PCN #: 2485 – Rev 2 - (Automotive)

PCN Title: Qualification of Internal "Diodes Technology (Cheng Du) Company Limited" (CAT) as Additional Assembly & Test Site Using PdCu or Au Bond Wire, And Qualification of Additional Wafer Source for Select Discrete Automotive Products

PRODUCT CHANGE NOTICE

PCN-2485 REV 2

SOP-8L

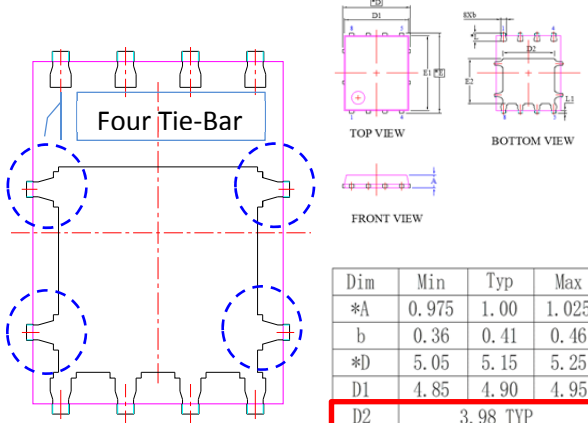
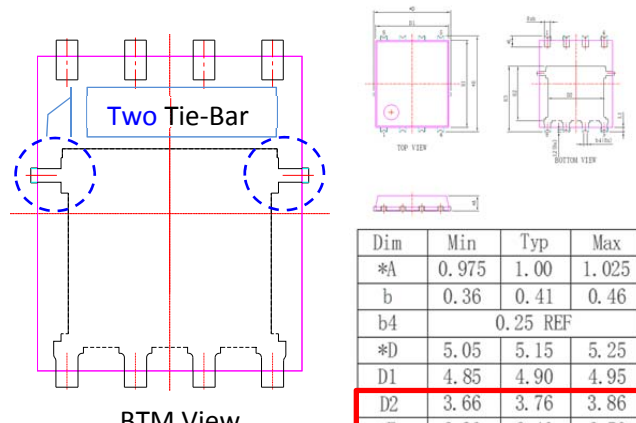
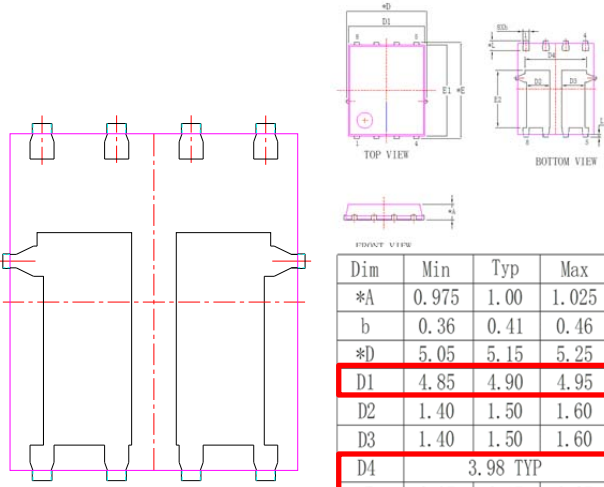
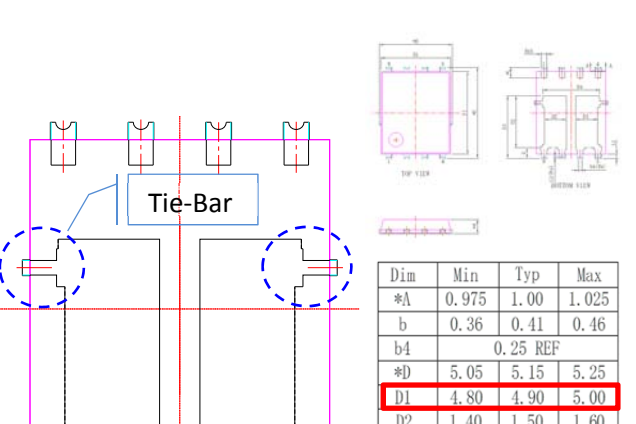
SAT (Diodes Internal AT site Shanghai, China)	CAT (Diodes Internal AT Site Chengdu, China) Bar "-" above Y indicates CAT
Marking format example	Marking format example
